Office Action Summary

10/019,195

HANNIG ET AL.

DETAILED ACTION

Claims 39-45 (as best understood by the examiner, see 35 U.S.C. 112 rejections above) are rejected under 35 U.S.C. 102(b) as being anticipated by Hoffmann USPN 3731445 (see marked-up figure below).

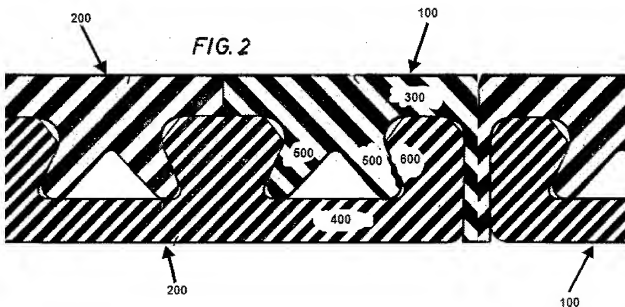
The prior art discloses applicant's claimed fastening system structure (as best understood by the examiner, see 35 U.S.C. 112 rejections above) to include a first panel (100) having a first hook projection (500), first leg (300) and inclined retaining surface (surface of 500 contacting 600); a second panel (200) having a second hook projection (600), second leg (400) and inclined retaining surface (surface of 600 contacting 500); there being a gap-free floor surface (where top

surface of 100 meets top surface of 200), there being a space (space extending between 600 and 300; and also extending between 600 and 500), in as much as applicant's own elected species does (see 35 U.S.C. 112 rejections above).
